82527

Specification Update

June, 1998

Order Number: **272876-002**

Figure 1. Bus Cycle for Mode 0 or Mode 1 Operation (Read Cycle)

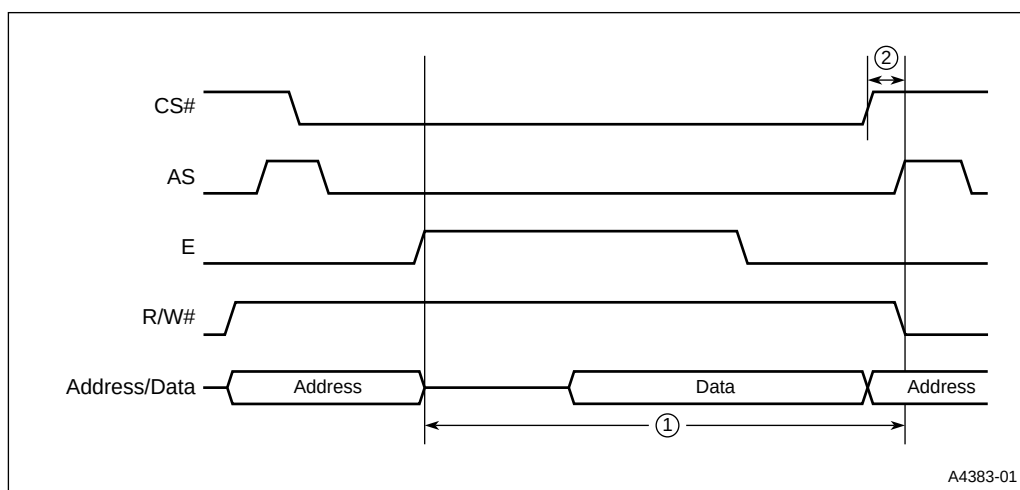
For mode 0 and mode 1 (Intel multiplexed modes), the control signals ALE, RD# and WR# are used to define the address and whether the cycle is a data read or write operation. The ALE signal is commonly used to latch the address information and generate a CS# signal to the 82527. The problem occurs in this configuration when the next cycle ALE is asserted before CS# of the current cycle becomes invalid. This circumstance presents a problem only when CS# is active and the next cycle's ALE occurs less than $1.5 t_{MCLK}$ after the current cycle's RD# low. ($t_{MCLK} = t_{OSC}/[(1 + DSC \text{ bit}) + DMC \text{ bit}]$ where DSC = Divide System Clock, DMC = Divide Memory Clock.

When performing “fast reads” associated with the double-read operation in mode 0 or 1, one of the following two conditions must be true:

1. The time from RD# low of the current cycle to the next ALE must be greater than $1.5 t_{MCLK}$, or
2. The CS# signal to the 82527 must be inactive before the next occurrence of an ALE, when the time from the RD# low of the current cycle to the next cycle's CS# active is less than $1.5 t_{MCLK}$.

Figure 2. Bus Cycle for Mode 2 Operation (Read Cycle)

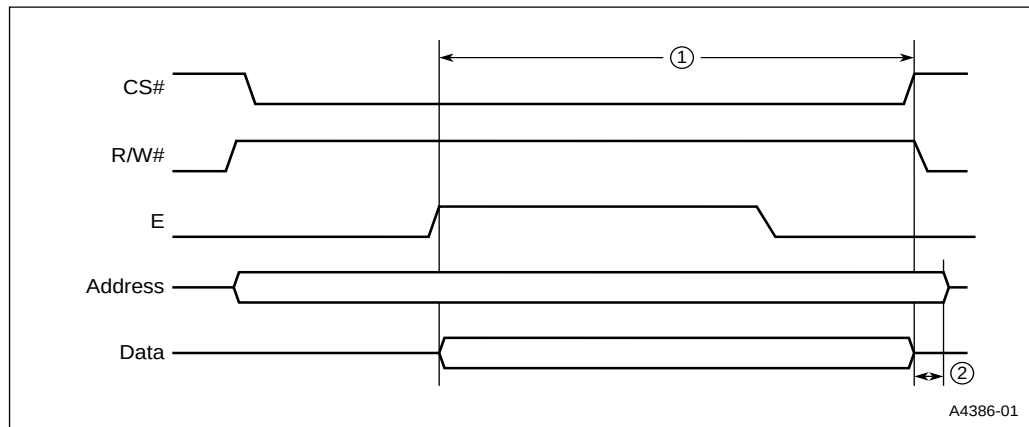
For Mode 2, the control signals AS, R/W#, and E are used to define the address, to specify whether the cycle is a data read or write operation, and to synchronize the memory accesses. The AS signal is commonly used to latch the address information and generate a CS# signal to the 82527. The problem, as outlined for Modes 0 and 1, occurs when the next cycle's AS is asserted before CS# of the current cycle becomes invalid. This circumstance presents a problem only if the next cycle's AS occurs in less than $1.5 t_{MCLK}$ after the current cycle's E low while CS# is still active.

For Mode 2 operation, one of the following two criteria must be true:

1. The time from E high of the current cycle to the next AS must be equal to or greater than $1.5 t_{MCLK}$, or
2. The CS# signal to the 82527 must be inactive before the next occurrence of an AS, when the time from E high of the current cycle to the next cycle CS# active is less than $1.5 t_{MCLK}$.

Figure 3. Bus Cycle for Mode 3 Synchronous Operation (Read Cycle)

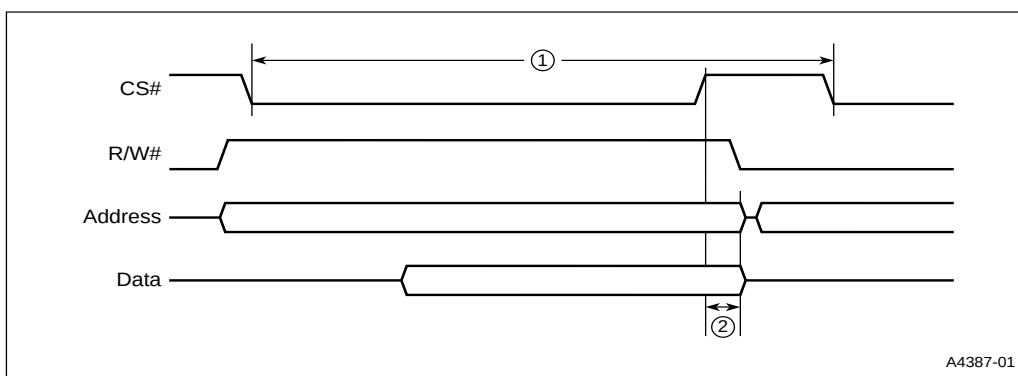
For mode 3 synchronous operation, there is no ALE or AS signal. Mode 3 is the demultiplexed mode of the 82527. For this mode, the address information must be present through the entire cycle. However, when performing fast read operations, similar considerations as the other modes must be observed to prevent problems when performing reads from the 82527.

For mode 3 synchronous operation, one of the following two criteria must be true:

1. The time from E high of the current cycle to CS# invalid must be equal to or greater than $1.5 t_{MCLK}$, or
2. Address information must remain valid on the bus until after CS# goes inactive.
